PECO ENERGY

Subject: Peach Bottom Atomic Power Station, Units 2 and 3
Response to Request for Additional Information
Regarding Power Rerate Program (RAI-6)

**RESPONSE TO REQUEST FOR ADDITIONAL INFORMATION (RAI-6)
PEACH BOTTOM ATOMIC POWER STATION, UNITS 2 AND 3**

FIGURE 14.6.10

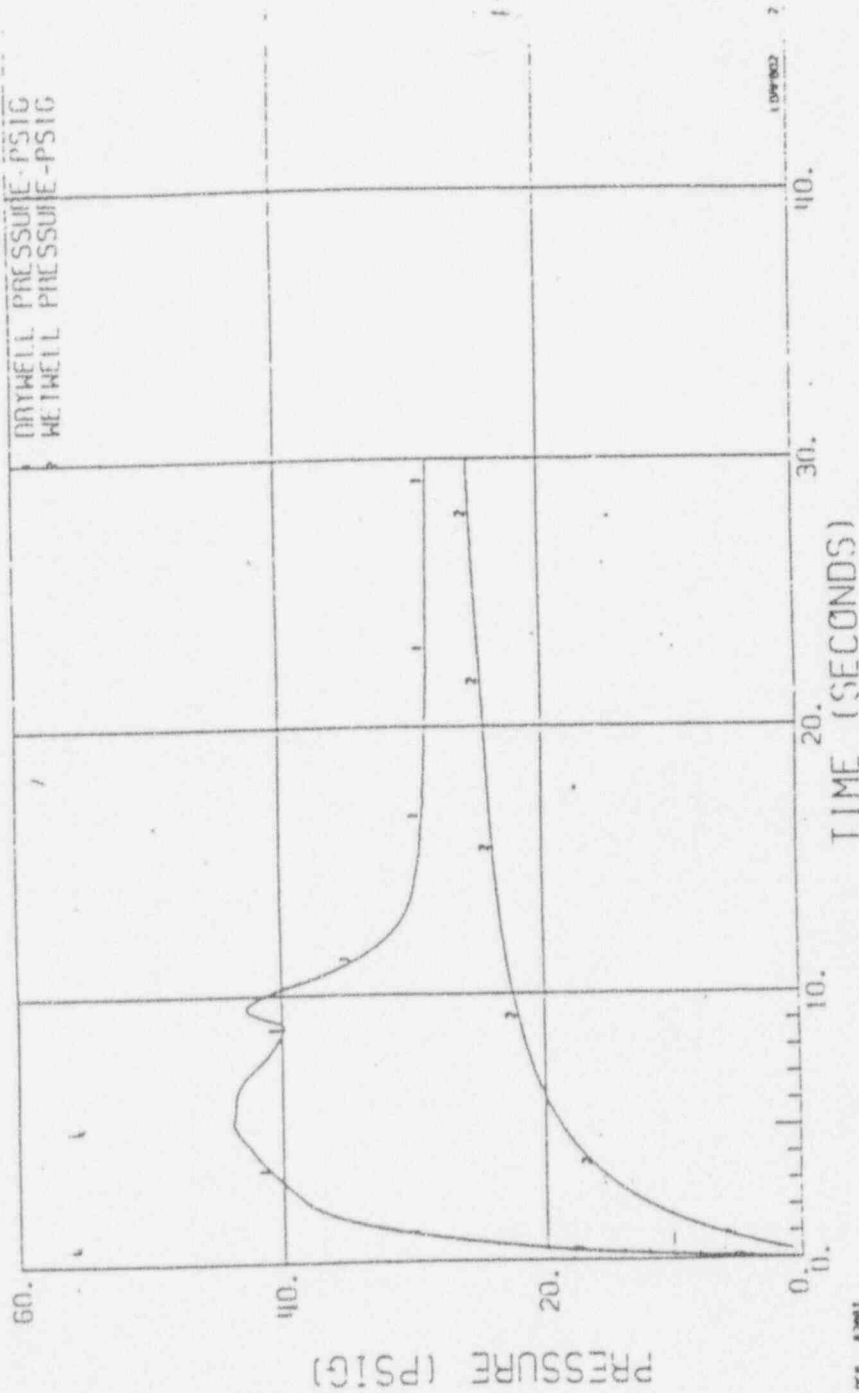
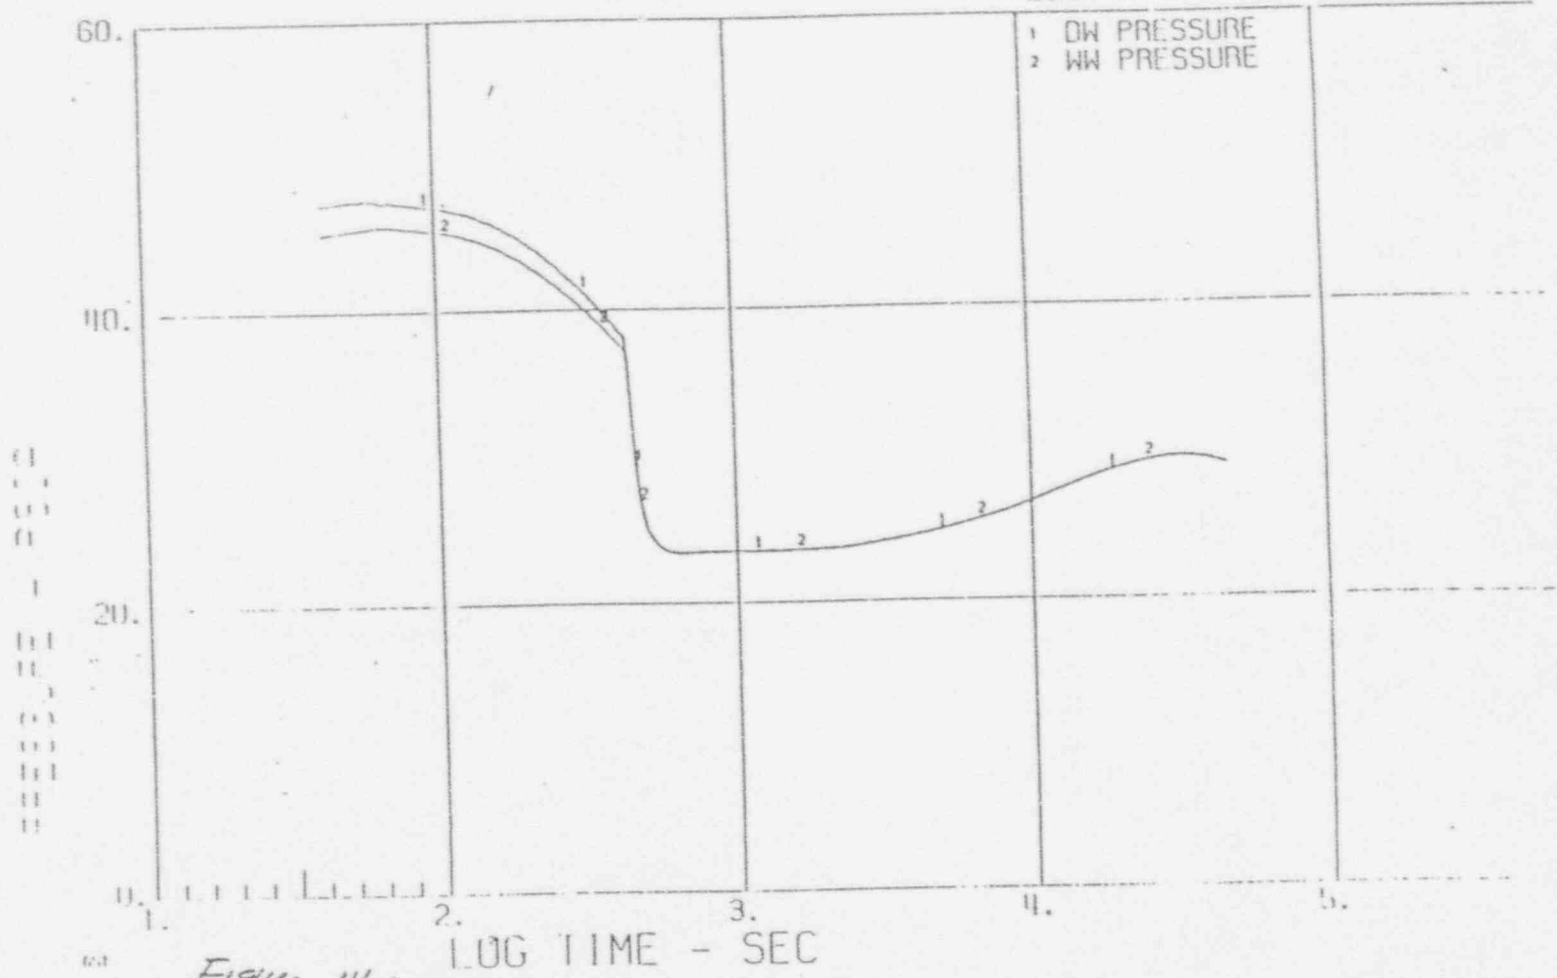
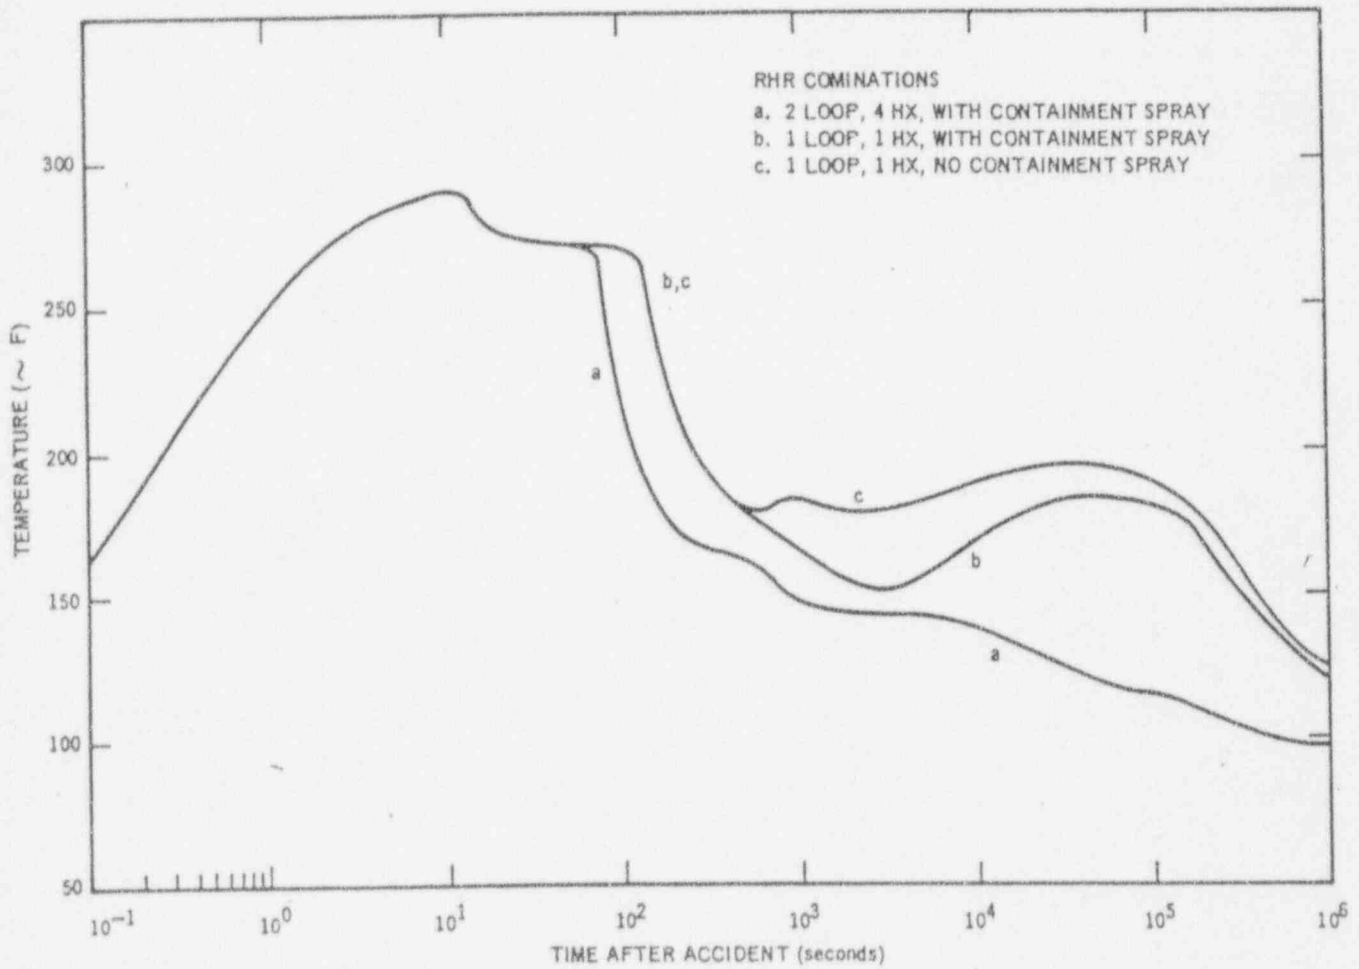
"Provide the containment analyses or a list of key input parameters that are different from the original analyses, a brief discussion as to why they are different, and a pressure/temperature graph for the final results."

The pressure/temperature graphs are shown in the PBAPS, Units 2 and 3 UFSAR markups for Figures 14.6.10, 14.6.11, and 14.6.12 (attached).

Note: Historical information - not accurate for current plant conditions. (See Figure 14.6.10 A & B)
